**Service Information**

**SUBJECT: CORRECTING DRIVEABILITY COMPLAINTS DUE TO EXCESSIVE LINE PRESSURE**

**ISSUE: 06/89-1151**

**APPLICATION: ALL 9000 MODELS, 1988- 900 MODELS**

**Figure 1.** The return fuel line check valve located at the fuel tank.

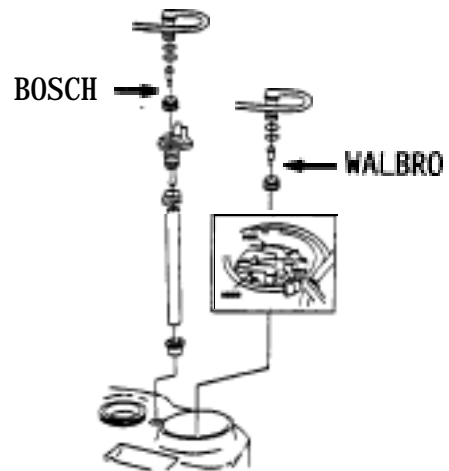
On vehicles with the fuel return line check valve integrated into the fuel line at the tank (Figure 1), it is possible for the rubber flap that acts as the check valve to become detached and block the return line or the ejector pump. A blocked or restricted fuel return line will cause driveability complaints due to excessive line pressure. This complaint can be diagnosed by measuring the fuel system pressure with a pressure gauge or the LH Tester. To prevent this, a revised check valve has been introduced into early-M89 production. The redesigned check valve consists of a new lower housing to the return line fitting and a valve core insert (Figure 2). This check valve may also be used to correct earlier cars.

Figure 4. Old-design check valve with rubber flap.

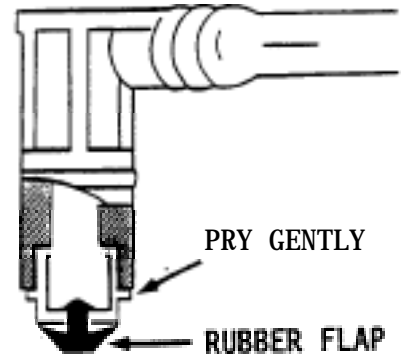
3. If the rubber flap is missing from the old-design check valve (Figure 4), it will be necessary to follow one of the steps (4A or 4B) listed below to remove any remnants of the flap.

4. Remove the existing lower valve housing by prying gently at the joint with a screwdriver (Figure 4).

A) On cars with Walbro pumps, see the ejector cleaning procedure in the 900 Service Manual Section 0, "News" for 1989, p. 36-37. (For Warranty repairs, add labor operation for "R & R Walbro Feed Pump").

B) On cars with Bosch pumps, remove the fuel tank fitting for the return line and clean it with compressed air. Inspect and replace the return line grommet if necessary.

Figure 5. Install the valve core insert into the housing. Install the check valve assembly into the return line fitting.

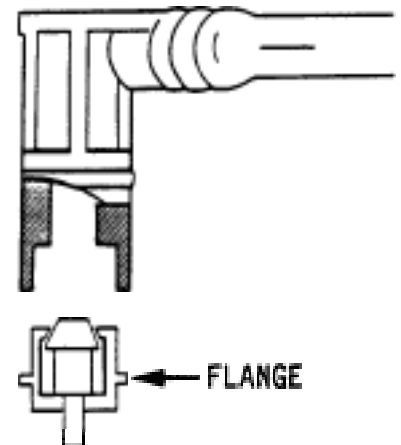
5. Insert the new check valve insert into the new check valve housing. Install this check valve assembly into the return line housing. (Figure 5). The collar of the new housing should engage the groove in the return line fitting when the flange is flush against the bottom of the fitting (Figure 5).
